Staff Report for Item 9

Application Number: 16-3452

Address: #516 Bahama Street

Replacement of historic windows with new wood windows.

PROPOSED DESIGN

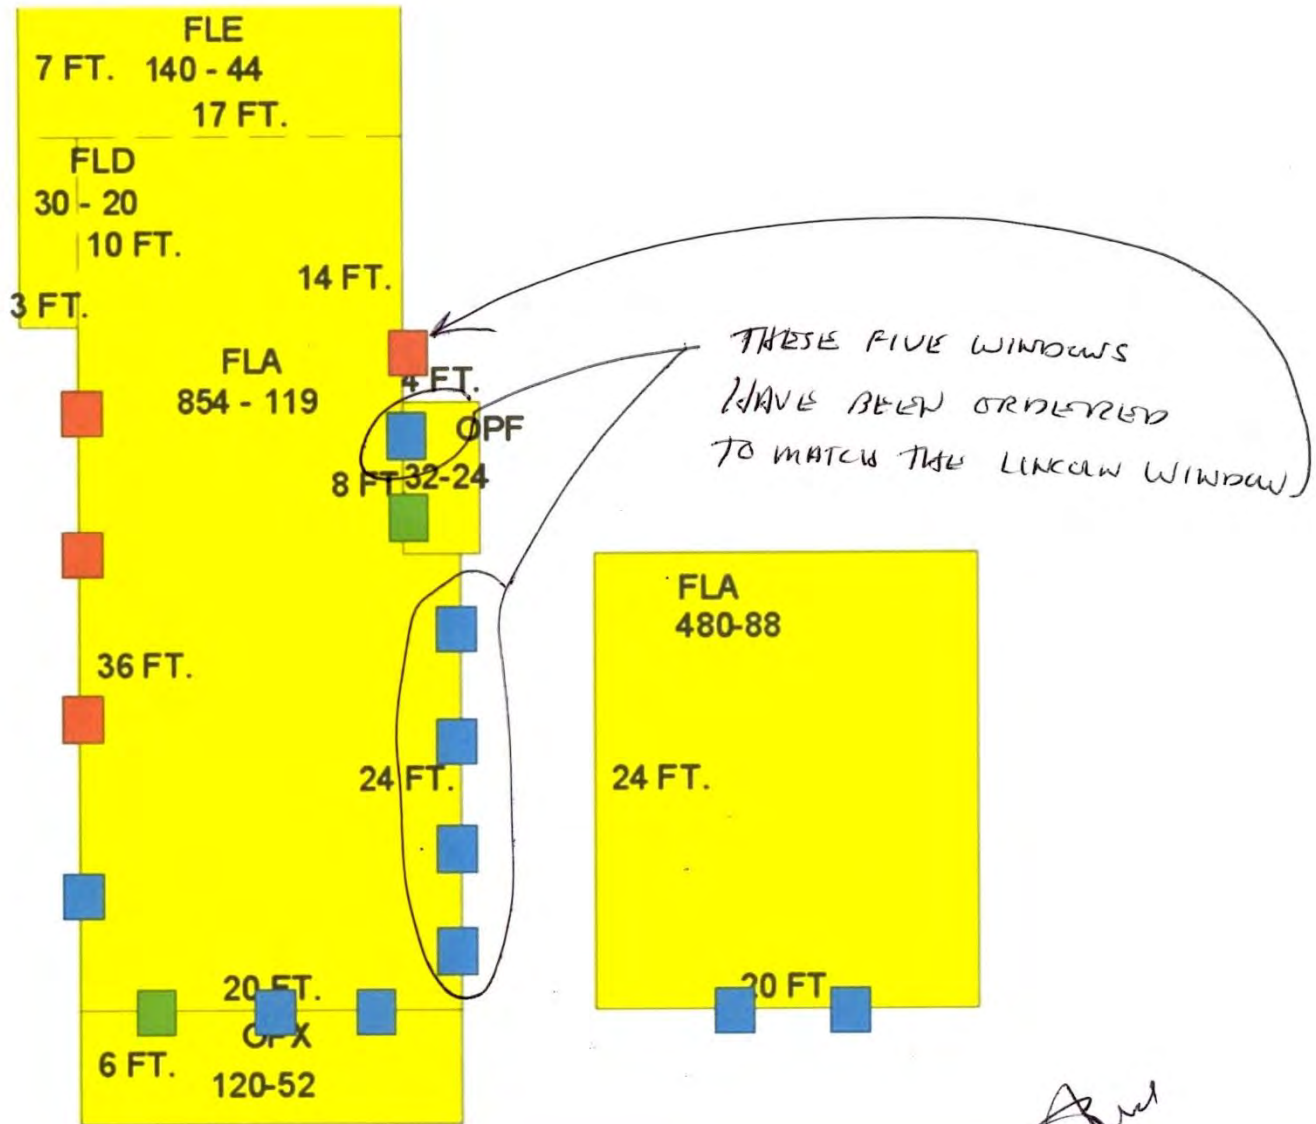
I have reviewed your application to replace five windows. I need to know exactly which windows. I went to the site, and the building has a lot of historic windows, which I cannot staff approve the removal of. That would need to go to the HARC Commission, because the windows look repairable. I created a window site plan, so if you could specific which windows you are proposing to remove.

You sent me a e-mail on 9-1-16 inquiring as to which windows I intended to replace along with a window plan, and a link to repairing /or restoring historic windows. I marked the plan to indicate the windows in question, and returned the plan. On 9-02-16 you replied the windows in question were Historic windows, and that I would have to go before the board for approval.
